IMPORTANT NOTICE

Note regarding Holley GM LSx with front mounted camshaft sensors:

199R10597

Proper Holley Harness Connection Location

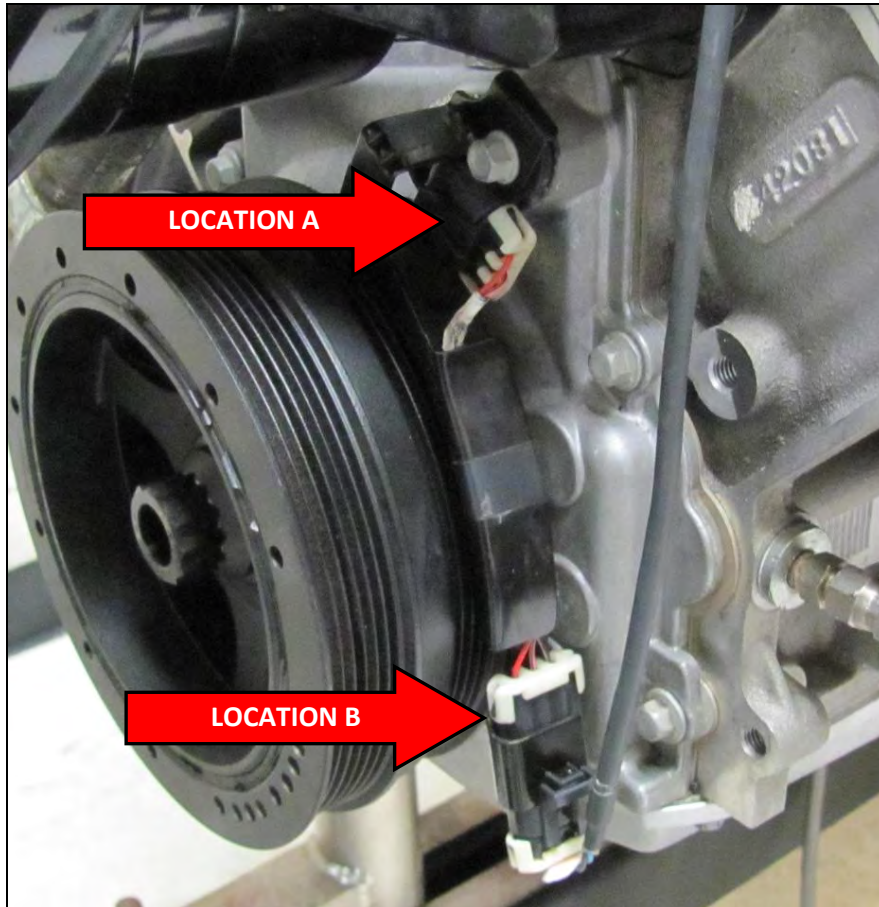
The main harness that goes into 550-603 (HP ECU & Harness 58x) and 558-103 (58x Main Harness) has had a revision. Harnesses produced prior to March 1, 2012, are labeled with part number "271R962A". The cam sensor harness is designed to plug directly into the OEM sub harness, location "B" below. Harnesses produced after March 1, 2012 are labeled with part number "271R962-1A", and are designed to plug directly into the cam position sensor, location "A" below.

The harness in this kit is the 271R962-1A harness. The cam position sensor should be plugged directly into the sensor itself.
